Access Compliance Report Public Rights-of-Way (Curb Ramps)

Main Street: BOSTONIAN_DR Cross Street: FOSTER_RD Location: SE

ADA ID: RPRK211220132246 Ramp Type: Type 1 - Perpendicular Diagonal Initial Pass/Fail: Fail Overall Compliance: No Severity Score: 15

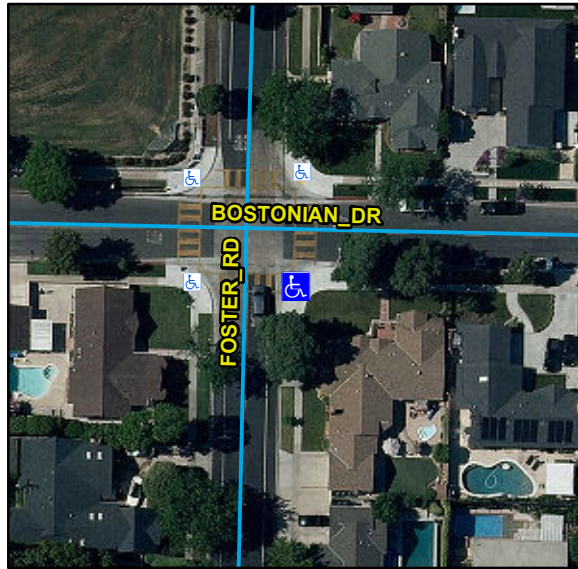
Compliance	Description	Data	Compliance	Description	Data
N/A	Ramp Length (in)	84	N/A	Flare Type LT	
Yes	Ramp Width (in)	48			N/A
No	Ramp Run Slope (%)	8.7	N/A	Flare Slope LT (%)	N/A
Yes	Ramp Cross Slope (%)	0.2	N/A	Flare Traversable LT	N/A
N/A	Landing Present	N/A	N/A	Flare Type RT	
N/A	Landing Length (in)	N/A			N/A
N/A	Landing Width (in)	N/A	N/A	Flare Slope RT (%)	N/A
N/A	Landing Run Slope (%)	N/A	N/A	Flare Traversable RT	N/A
N/A	Landing Cross Slope (%)	N/A	N/A	DWS Provided	N/A
N/A	Landing Movement Obstructed?	N/A	N/A	DWS Contrast	N/A
	Landing Movement Type	N/A	N/A	DWS Length (in)	N/A
N/A	Landing Shared	N/A	N/A	DWS Full Width	N/A
N/A	Clear Space	Yes	N/A	DWS Offset Left (in)	N/A
N/A	Clear Space To Crosswalk (in)	48	N/A	DWS Offset Right (in)	N/A
N/A	Marked Crosswalk 1	Yes	N/A	Marked Crosswalk 2	Yes
	Crossing 1 Direction	N		Crossing 2 Direction	W
	Marked Crosswalk 1 Width (in)	144		Marked Crosswalk 2 Width (in)	144

Remove & Replace Curb Ramp With Two New Directional Ramps or Equivalent.

R304.2.2, STD 1115
